## ST. TAMMANY PARISH

**Addendum No.:** 1

**Bid#:** 21-4-2

**Project Name:** Soult Street Road Improvements

SHEET NUMBER		20	
DESIGNED	CRH	ST. TAMMANY	PROJECT
CHECKED	RUB	PARISH	ENI 18000011
DETAILED	BBS	CONTROL SECTION	000-52
CHECKED	CRH	REVISION OR CHANGE ORDER DESCRIPTION	
SERIES NUMBER	17 OF 23	BY	
PLAN AND PROFILE SHEET			
STA. 177+00 TO STA. 181+50			
SOULT ST. ROAD IMPROVEMENTS

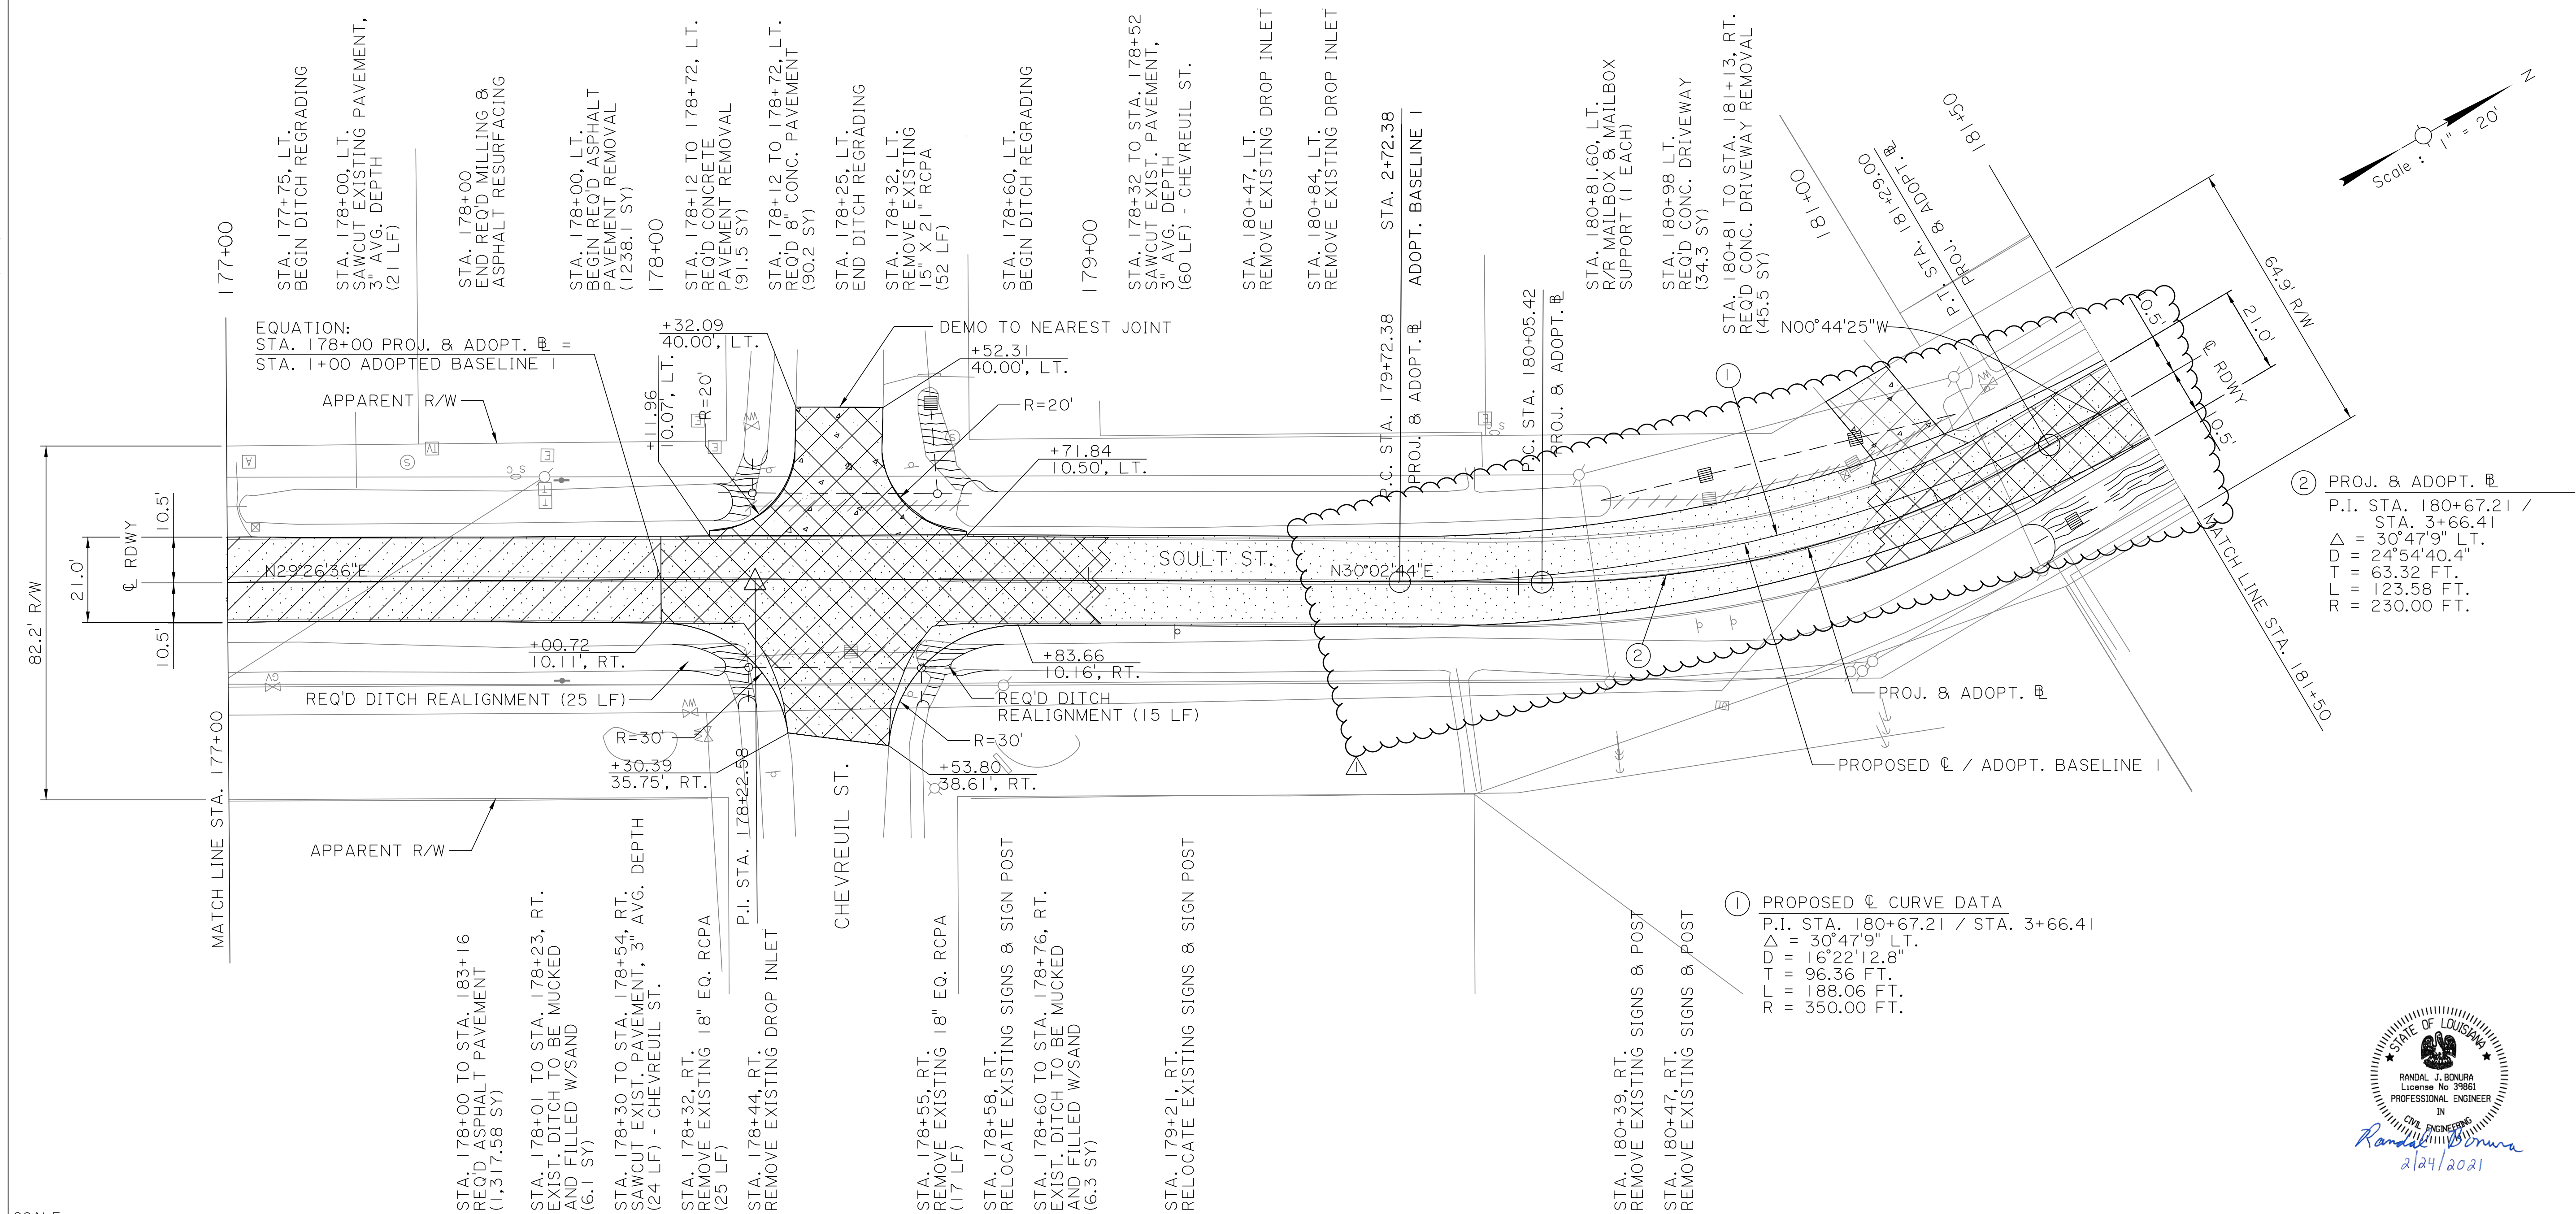
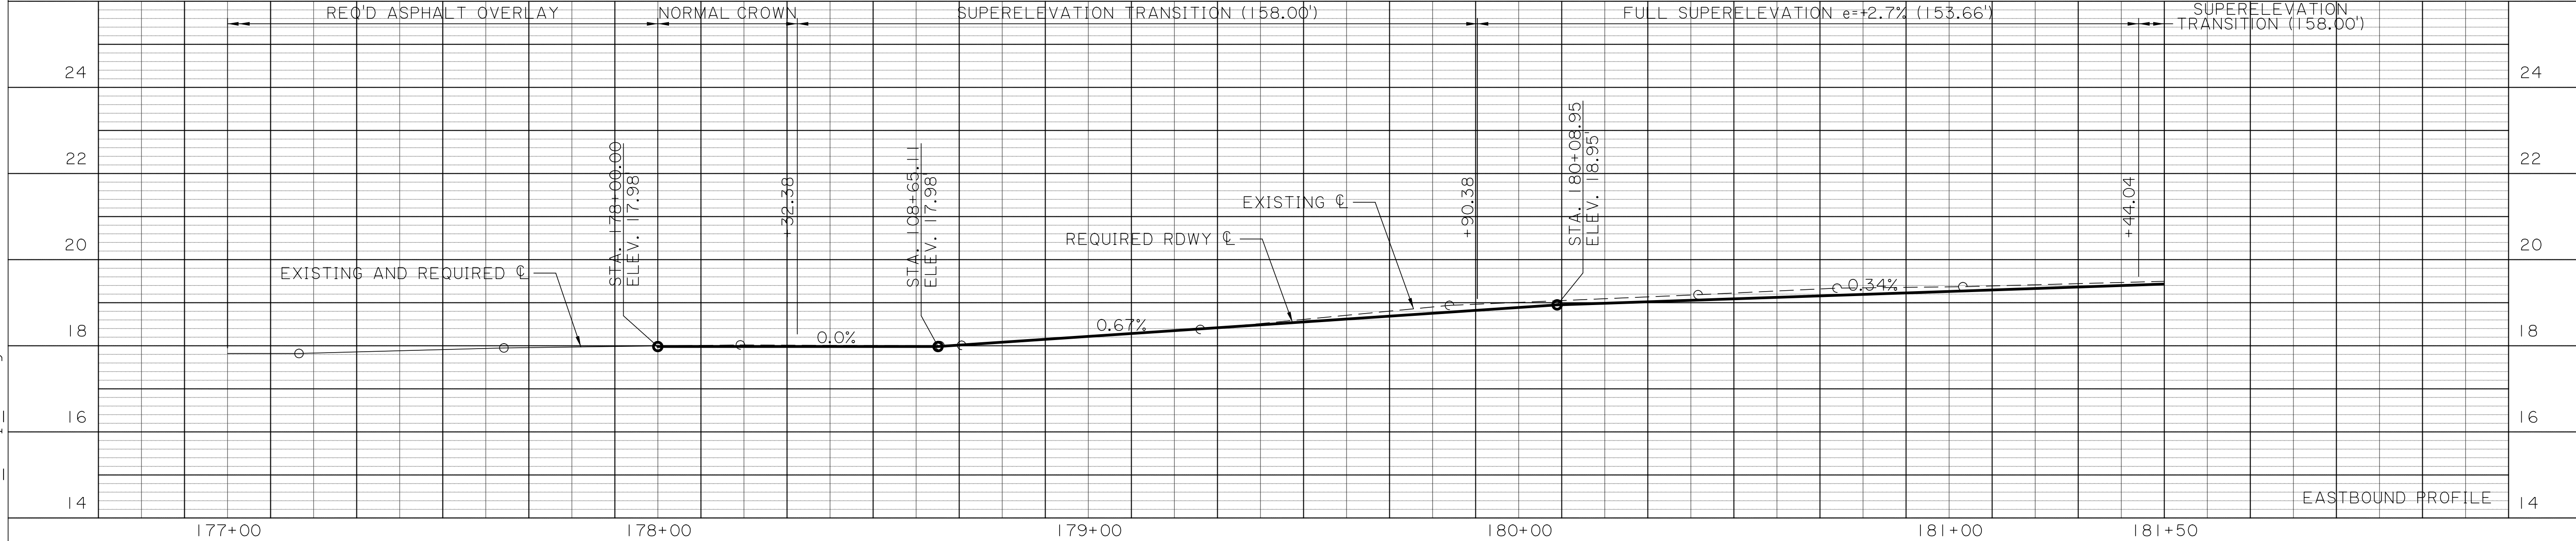
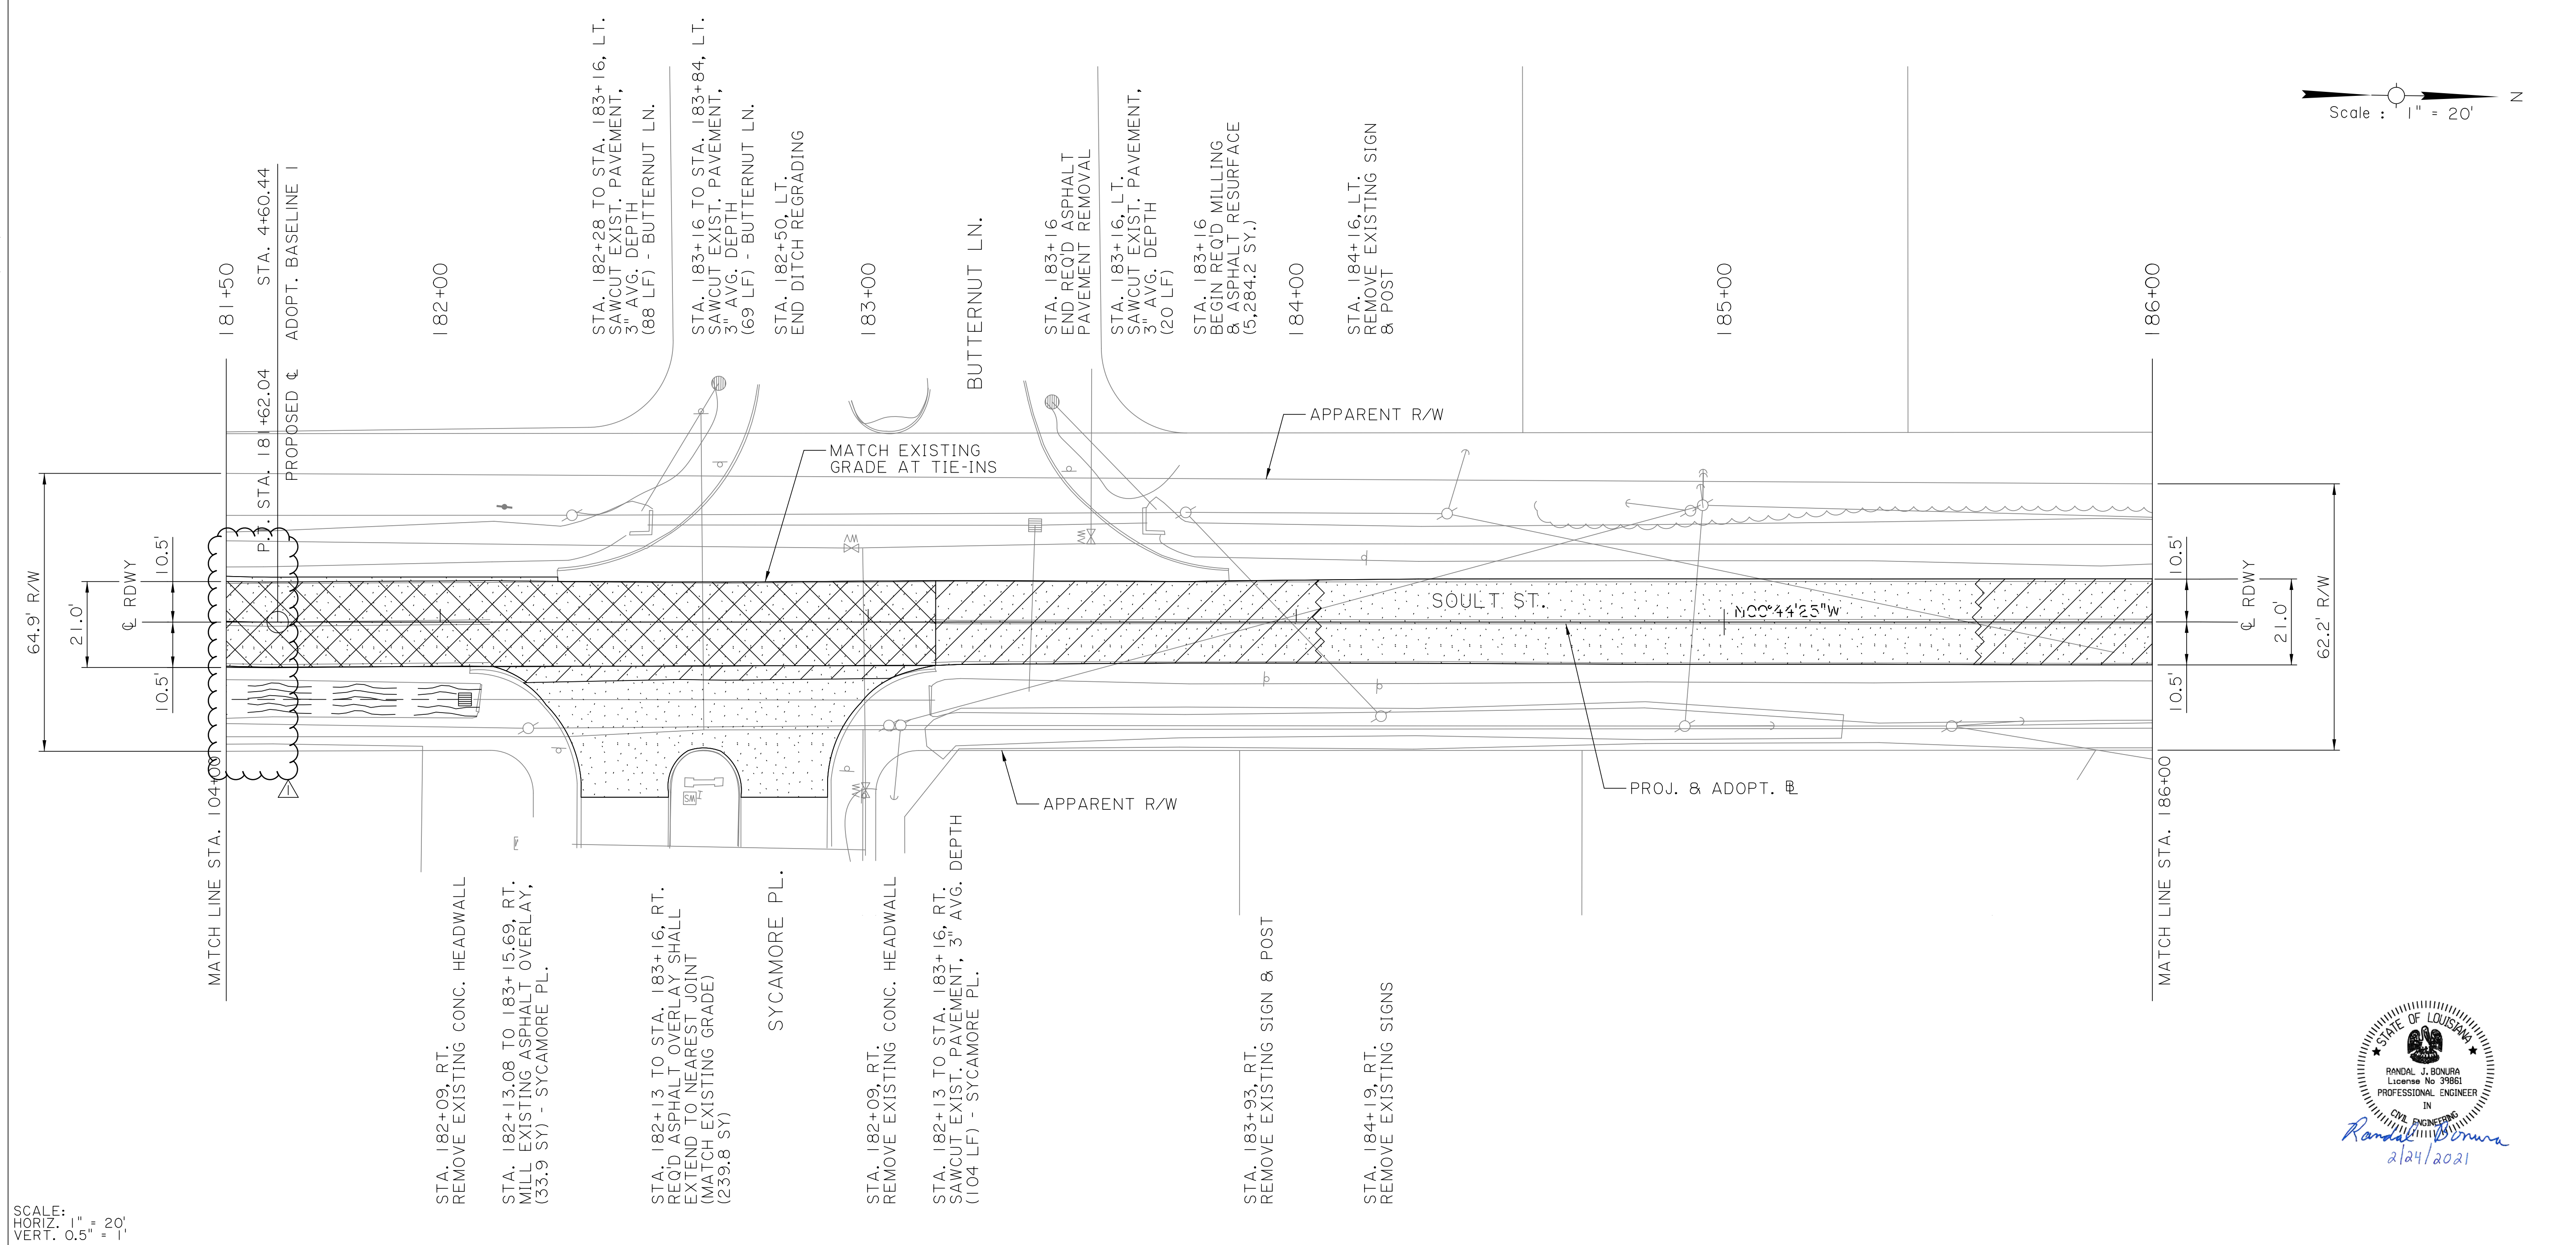
**Question 5.** SHEET 2C – TYPICALS reference station 1+00 to 1+32.32, 1+32.38 to 6+00.44, & 6+00.44 to 6+14.09. What roads are those stations located?

**Answer 5.** These stations correspond to the Soutl St. proposed centerline/adopted baseline 1 shown on plan sheet numbers 20 and 21. Sheet numbers 20 and 21 have been updated to show the baseline in plain view and are included with this Addendum.
